APPLICATION NO.	FILING DATE	FIRST NAMED INVENTOR	ATTORNEY DOCKET NO.	CONFIRMATION NO.
10/735,602	12/12/2003	Hao-Jan Lin	JCLA10516	1741

Office Action Summary

DETAILED ACTION

FIG. 2

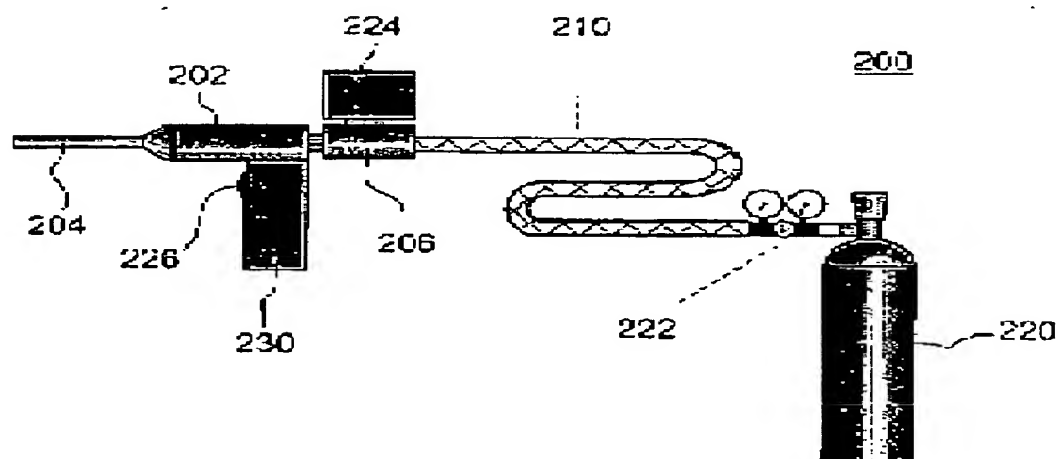
In addition, it is unclear whether “the control” is a structural component of the gene gun apparatus or whether the limitation “the control” is meant to signify an action step taken in practicing the claimed process. The ambiguity is demonstrated by viewing Figure 2 reproduced below:

The structure marked **224** is indicated to be a control valve. The specification further indicates that “the controller” is not pictured thus the figure is not helpful in this regard. (Specification, ¶ 0034; all references to the Specification herein correspond to the published version of the application, i.e., 2004/0180442). The specification provides that “the controller” controls the “control valve **224**. Thus it is unclear whether “the control” is either an additional component or an additional step that controls the controller. If the limitation “the control” is intended to define the “control valve” the claims should be amended to clarify as such. Alternatively, if “the control” is meant to signify an action step of the “control valve” to regulate “the controller” then the claims should be amended accordingly. However, as written the claims are vague because it is unclear how the claims should be interpreted thus rendering indeterminable the claims’ metes and bounds.
